Re: **Addendum # 1**
SEABREEZE SHORE REMEDIATION PROJECT
NJDEP - DIVISION OF COASTAL ENGINEERING
PROJECT NUMBER 4248-13

NJDEP Project #4248-13
Seabreeze Shore Remediation Project
Addendum #1: (Q&A) - 9/4/2020

DELAWARE BAY

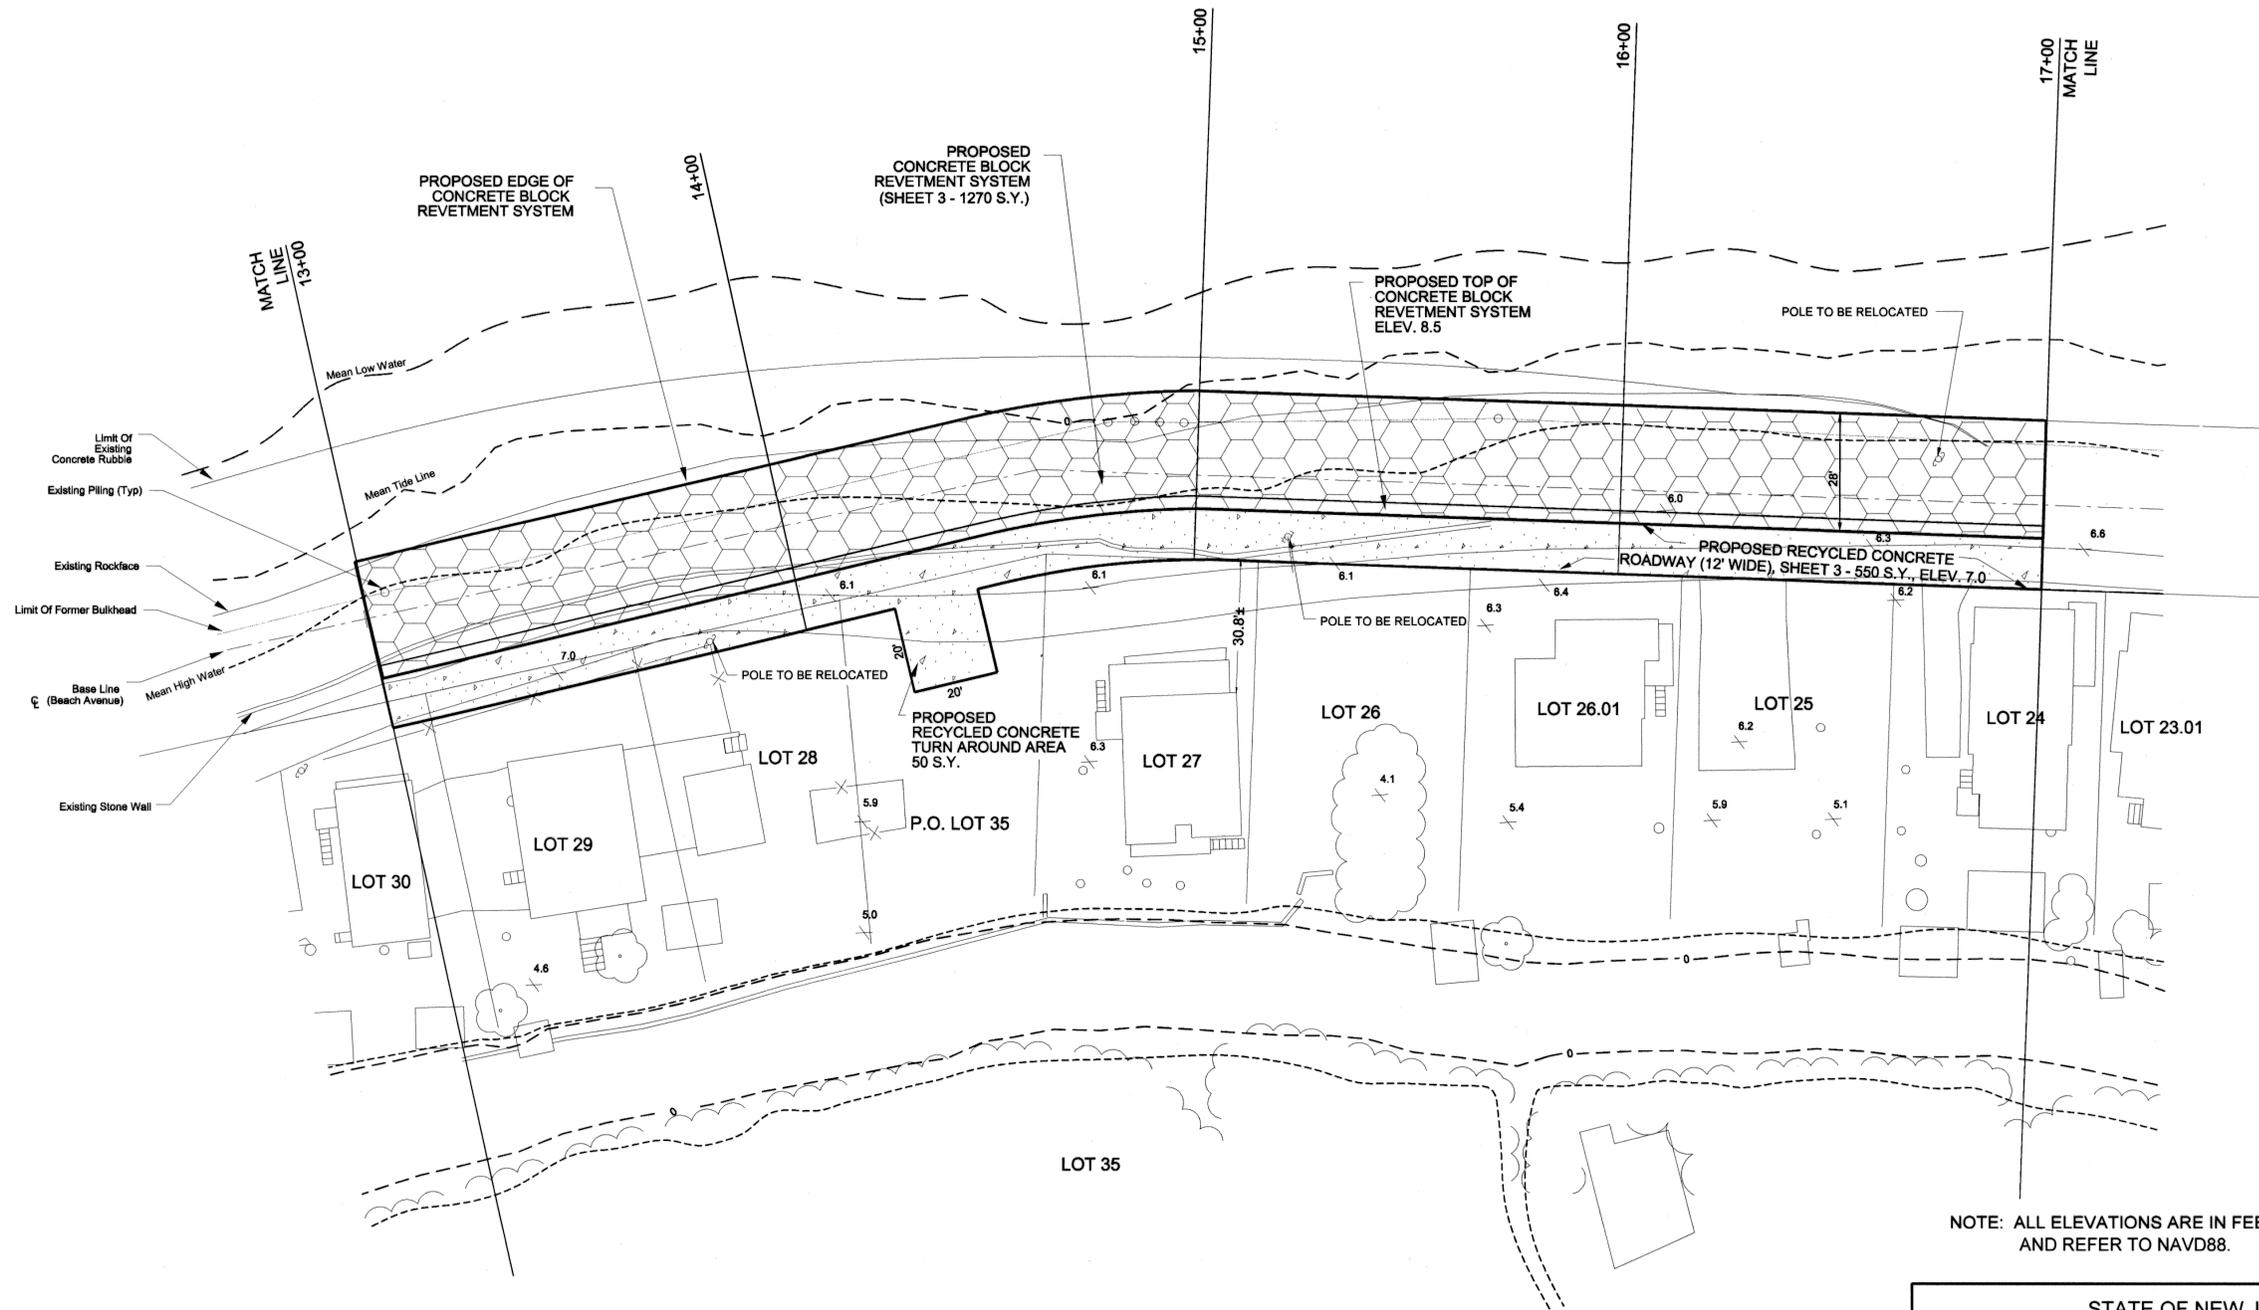
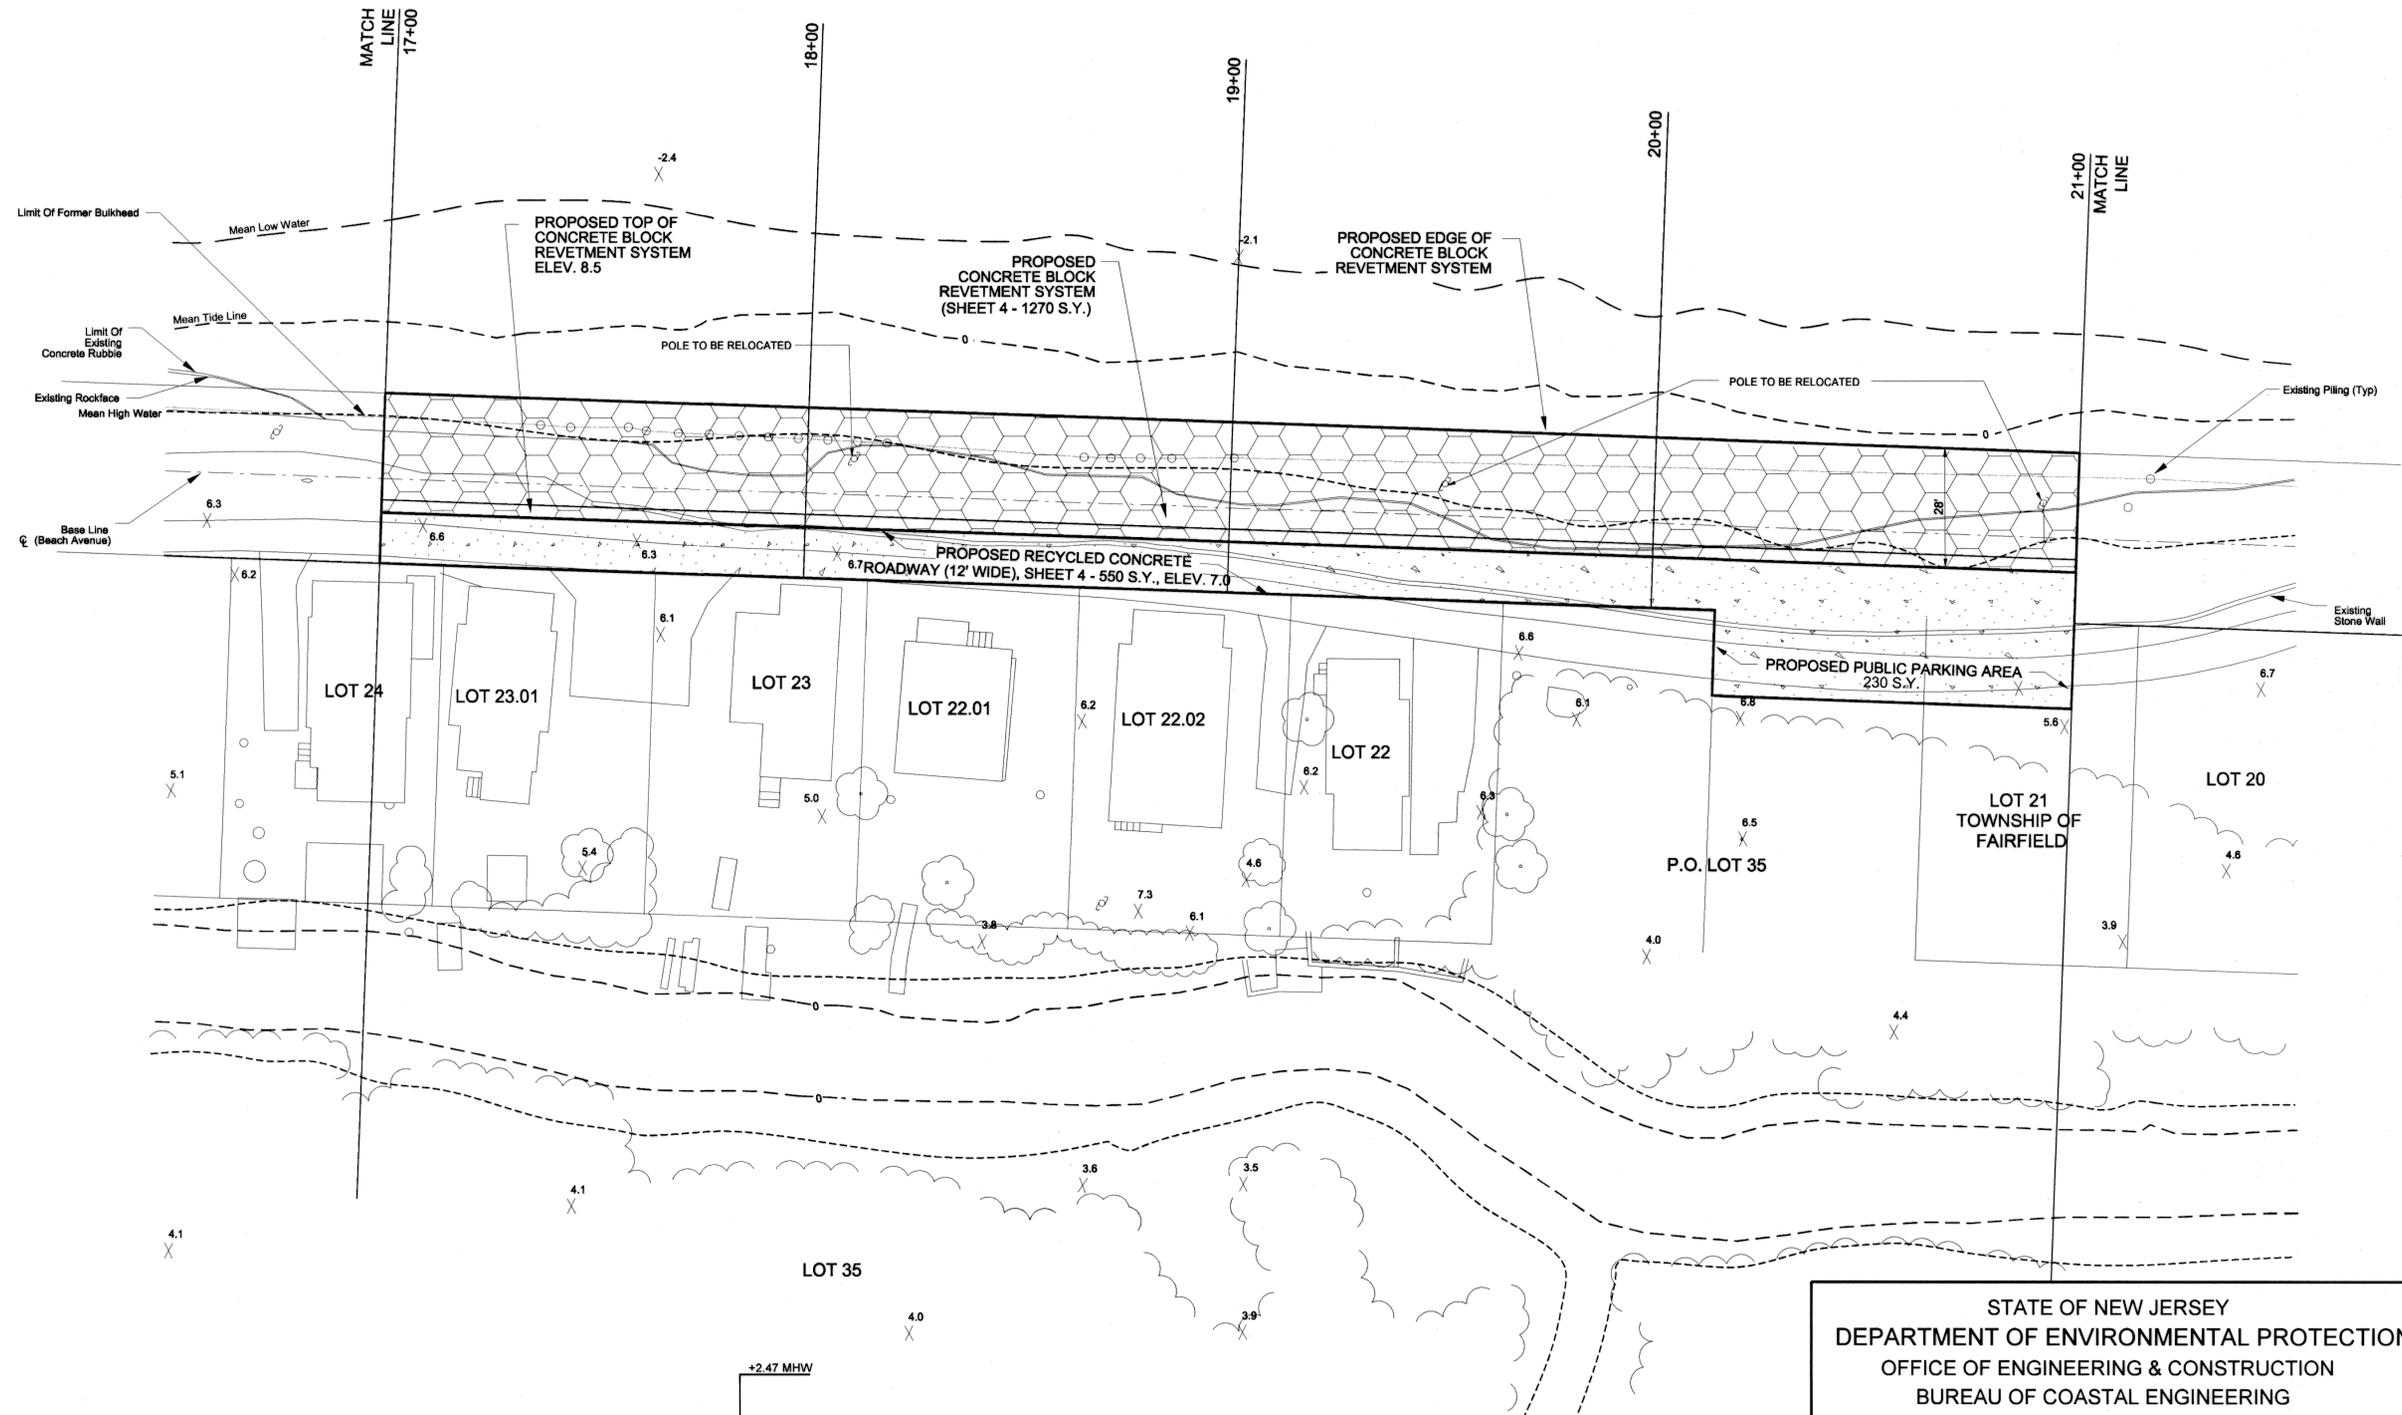
12. How much of the revetment is being left and buried?

A: The only portion of the revetment to remain and be covered with sand is at the turnaround area at the south end of the project (see plans for further detail). All other sections shall be fully removed, inclusive of the toed-in blocks (see Appendix AD1-2, Original Construction Drawings).
